ADDENDUM NO. 2
NEW JROTC FACILITY FOR PLEASANT GROVE HIGH SCHOOL
Architect Job No. 21-66
March 15, 2022
DCM No. 2021505
Bid # 12-22

The Plans and Specifications are hereby amended. The following supersedes all contrary and/or conflicting information and is made part of the contract documents.

JOB NO. **21-66**
SHEET NO:
C0.1

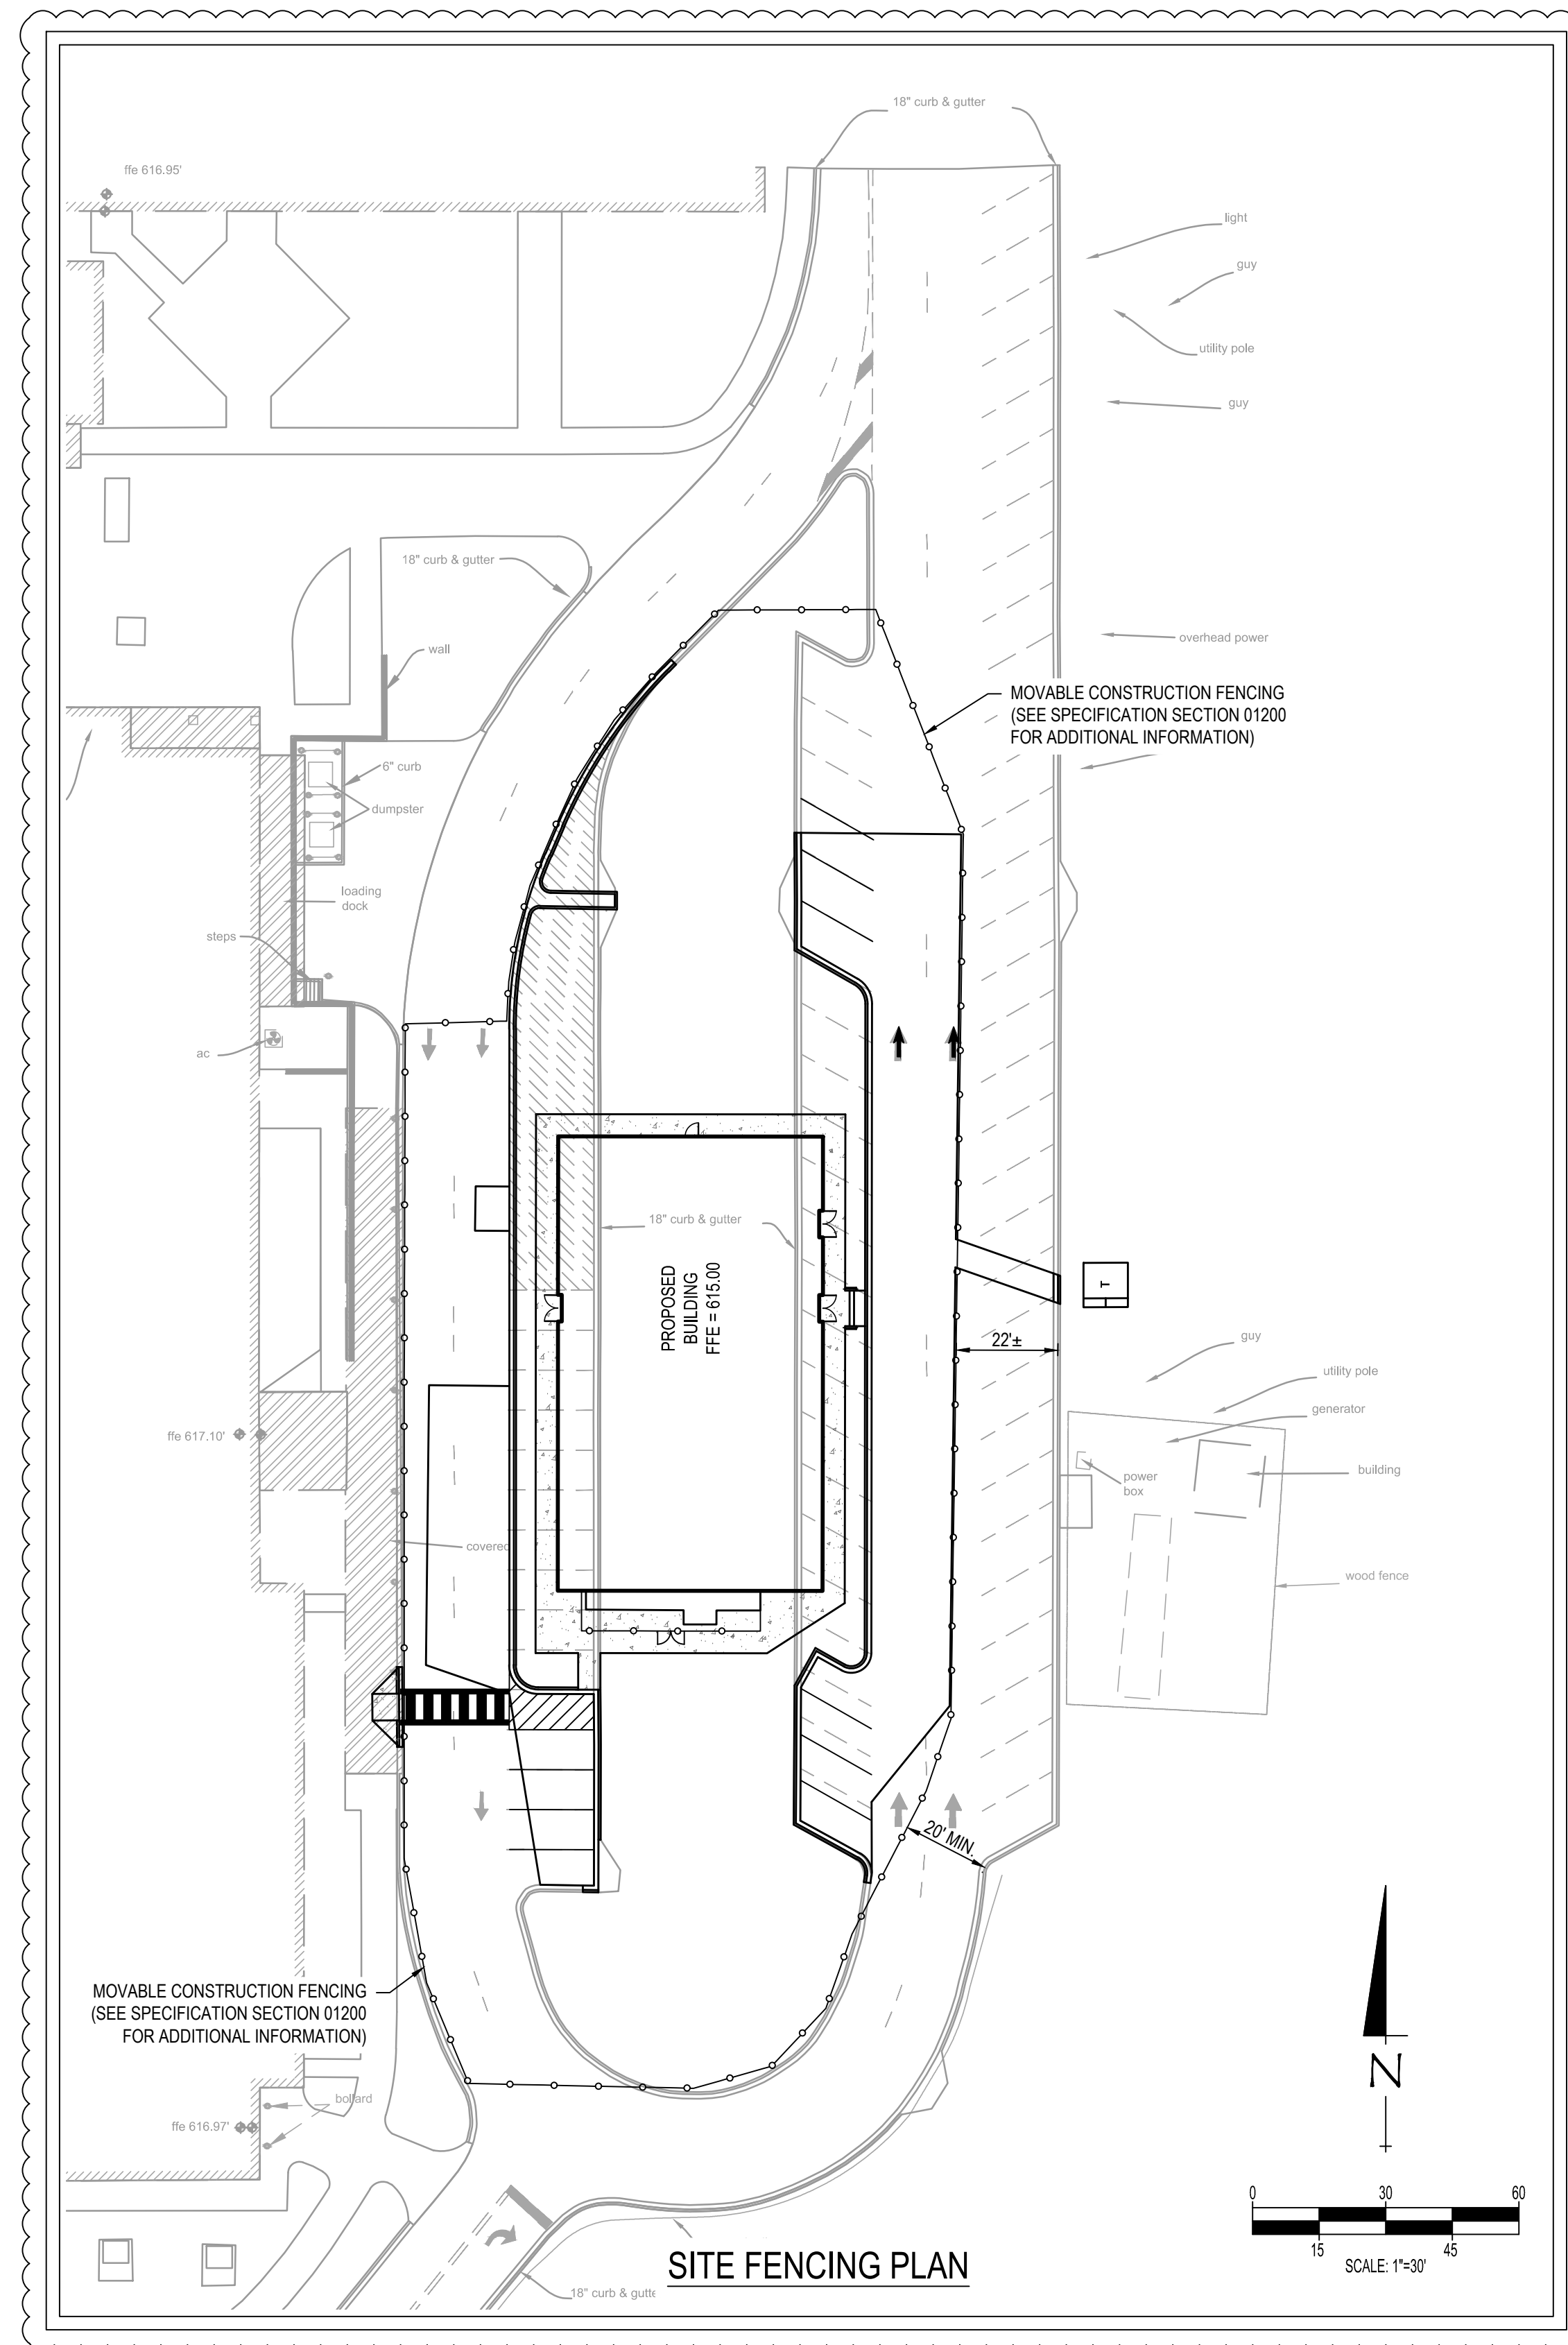
1. Attached Civil Drawing C0.1 to show construction fence layout.
